UN Regulation No. 43 (Safety glazing)

Proposal for Supplement 11 to the 01 Series of Amendments to UN Regulation No. 43 (Safety glazing)

Submitted by the expert from the Republic of Korea *

Figure 22
Determination of Zone I

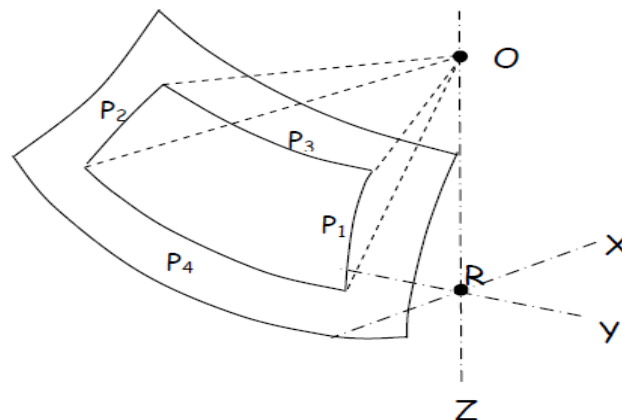
Paragraph 9.2.5.2.3, amend to read and insert a new figure 22:

"9.2.5.2.3. Zone I is the windscreen zone determined by the intersection of the windscreen with the four planes defined below:

In addition, opaque obscuration can be exempted in Zone I. It is the limited areas where it is intended that a sensing device, e.g. a rain-drop detector, rear view mirror or autonomous sensors, will be bonded to the inner side of the windscreen. The opaque obscuration where such devices may be applied is defined in paragraph 9.2.5.2.4. of this Annex.

Figure 23
Zone I (example of a left-hand steering control vehicle)
(Upper obscuration area as defined in paragraph 9.2.5.2.4.1.)

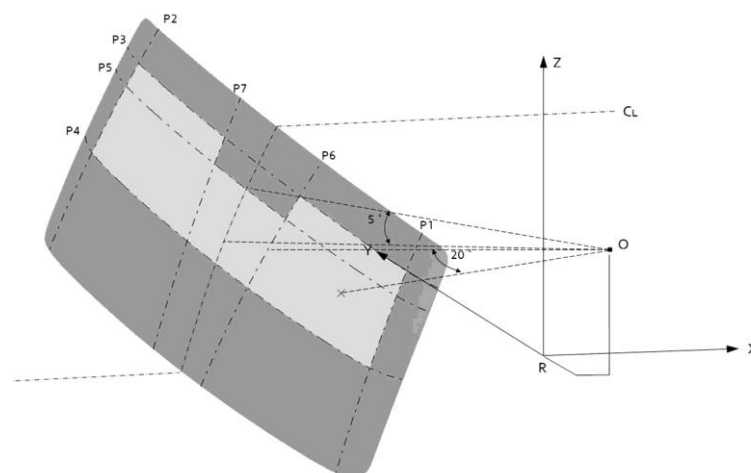
"
Insert new paragraphs 9.2.5.2.4., to 9.2.5.2.4.1., amend to read and insert a new Figure 23:

"9.2.5.2.4. Determination of the opaque obscuration

P5 – a plane passing through a transverse horizontal line containing O and forming an angle of 5° above the horizontal plane

P6 – a vertical plane passing through O and inclined at 20° to the right of the X axis in the case of left-hand drive vehicles and to the left of the X axis in the case of right-hand drive vehicles.

P7 – a plane symmetrical to P6 in relation to the longitudinal median plane of the vehicles.

9.2.5.2.4.1. Any opaque obscuration bounded downwards by P5 and laterally by P6 and P7. (See figure 23)
